Re: 21-26876
290 PARK RIDGE

Job	Truss	Truss Type	Qty	Ply	290 PARK RIDGE	I50438347
21-26876	B1XXX	Piggyback Base	1	1	Job Reference (optional)

Job	Truss	Truss Type	Qty	Ply	290 PARK RIDGE	I50438351
21-26876	B6XXX	Piggyback Base	1	1	Job Reference (optional)

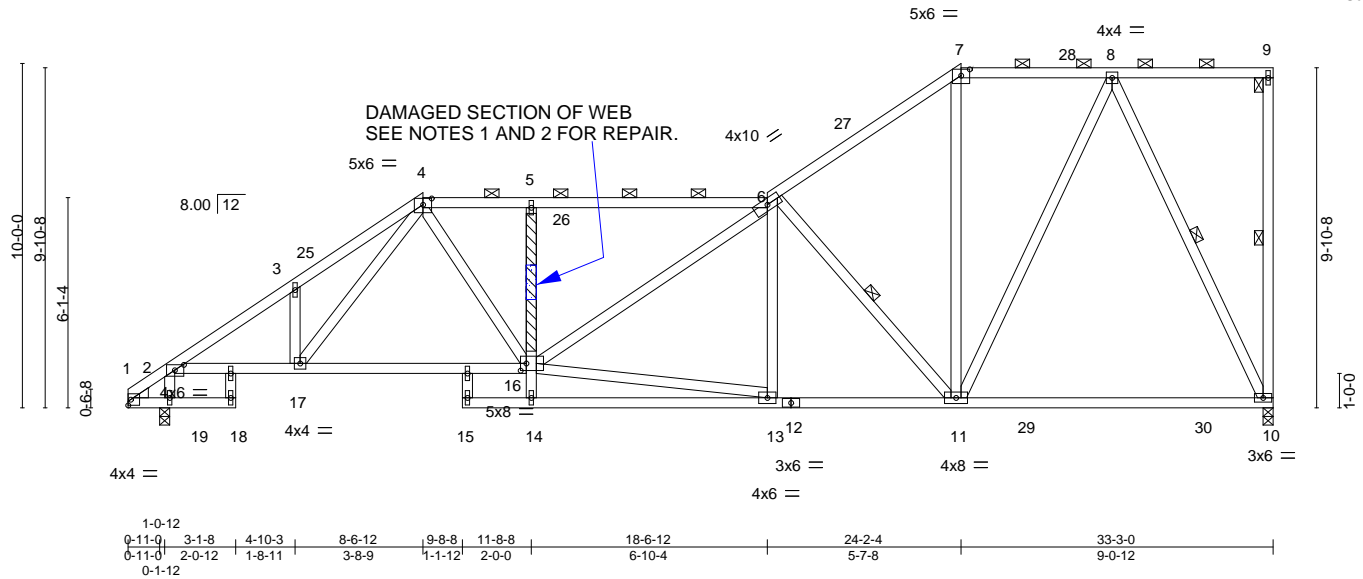
- 1) Repair Condition: web has damaged section 1-0-0 long starting 1-8-0 below joint 5.
- 2) Replace damaged section cut clean with same size and grade of material. Apply 48" long 2x4 SP No.2 scab to front side(s) of truss centered on damage located 2-2-0 below joint 5 with 2 row(s) of 10d (0.131"x3") nails spaced 2" o.c. from front face. Minimum 0-3-0 end distance.

Job 21-26876	Truss B8XXX	Truss Type Piggyback Base	Qty 1	Ply 1	290 PARK RIDGE Job Reference (optional)	I50438353
-----------------	----------------	------------------------------	----------	----------	--	-----------

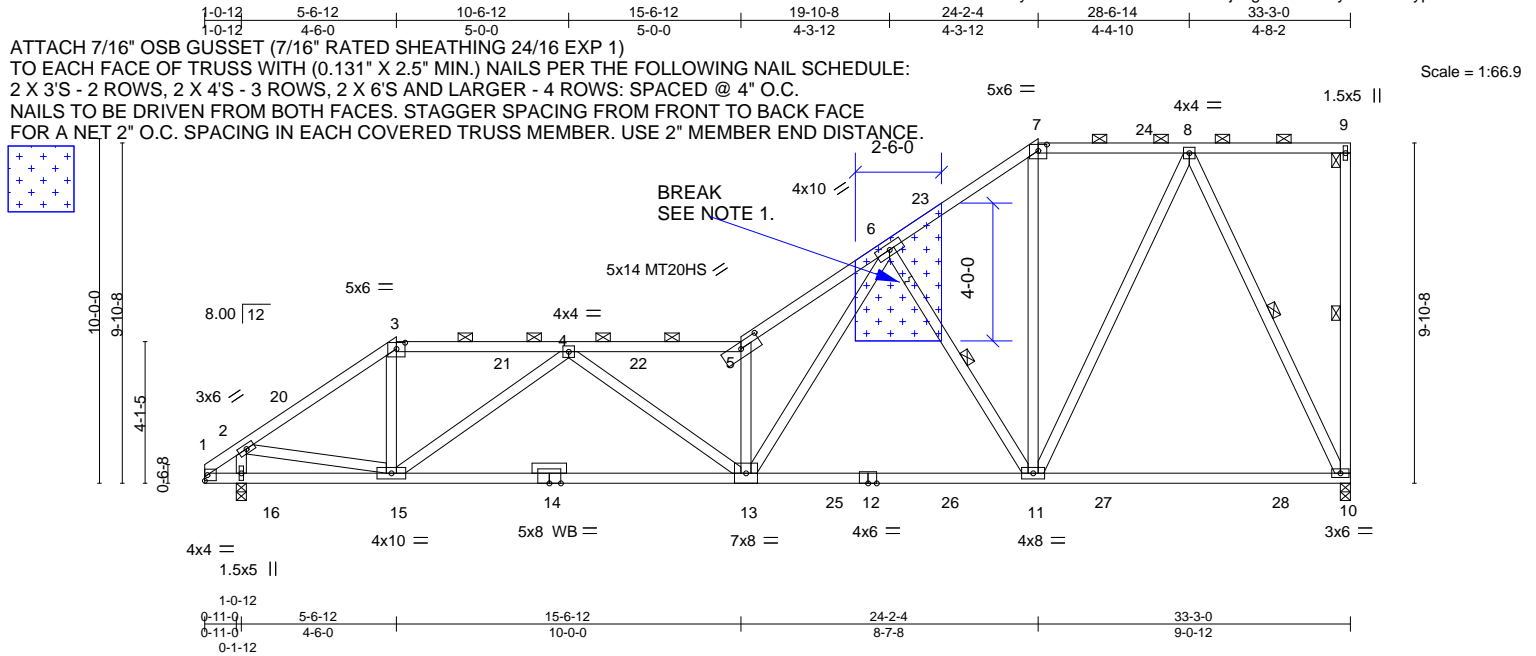
- 1) Repair Condition: web has 0-1-0 long break centered at 1-0-8 below joint 6.
- 2) N/A.
- 3) Unbalanced roof live loads have been considered for this design.

Job 21-26876	Truss C7XXX	Truss Type Roof Special	Qty 1	Ply 1	290 PARK RIDGE Job Reference (optional)	IS0438355
-----------------	----------------	----------------------------	----------	----------	--	-----------

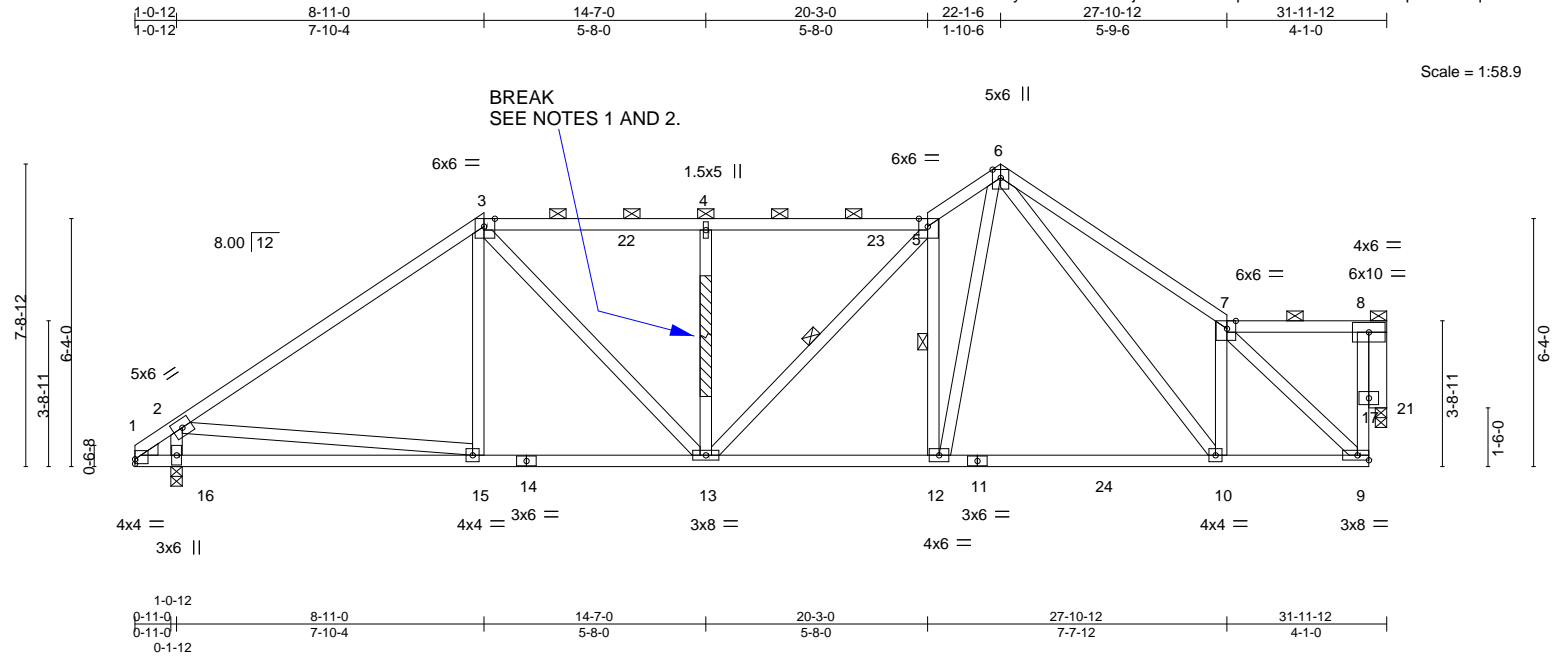
- NOTES-**
- 1) Repair Condition: web has 0-1-0 long break centered at 2-8-8 below joint 4.
 - 2) Apply 37" long 2x4 SP No.2 scab to front side(s) of truss centered on damage located 2-8-8 below joint 4 with 2 row(s) of 10d (0.131"x3") nails spaced 2" o.c. from front face. Minimum 0-3-0 end distance.
